Note

To obtain a higher idle speed at low ambient temperatures following a cold start, the vacuum box on ignition distributor (harder spring) and the connection for the ignition retard adjustment (white-yellow line) has been modified. The connection for the ignition retard adjustment is now on contoured hose between supplementary air valve and idle speed air distributor. The connection on throttle valve housing for ignition retard adjustment used up to now has been discarded.

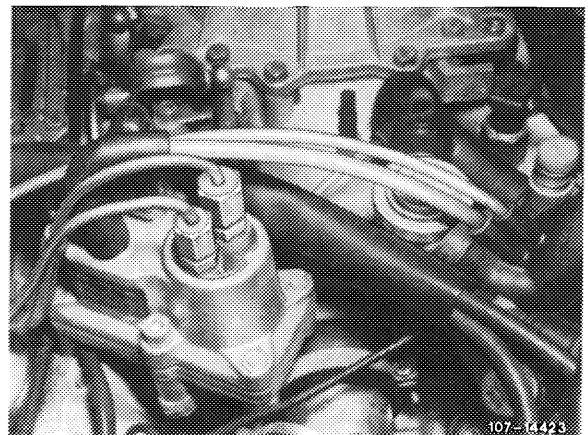
As a result of this change, the ignition is **not** adjusted toward retard at low ambient temperatures following a cold start as a result of the low intake pipe vacuum (supplementary air valve open). The idle speed will be raised by approx. 150–200/min immediately following a start.

- 1 Install modified contour hose.
- 2 Pull vacuum line white/yellow from throttle valve housing and connect to contour hose.
- 3 Close freed connection on throttle valve housing with rubber cap, part no. 000 987 11 45.
- 4 Mount new vacuum control unit for ignition distributor.

When renewing ignition distributor or vacuum box the connection for retard adjustment need not be changed.

When renewing contoured hose, close connection for retard adjustment blind, so that no false air will be drawn in.

When renewing throttle valve housing, install contoured hose with connection for retard adjustment, and on engine 117 the modified vacuum box.

The vacuum box on ignition distributor has not been changed. The speed increase following a cold start is attained through installation of contoured hose and modified throttle valve housing.
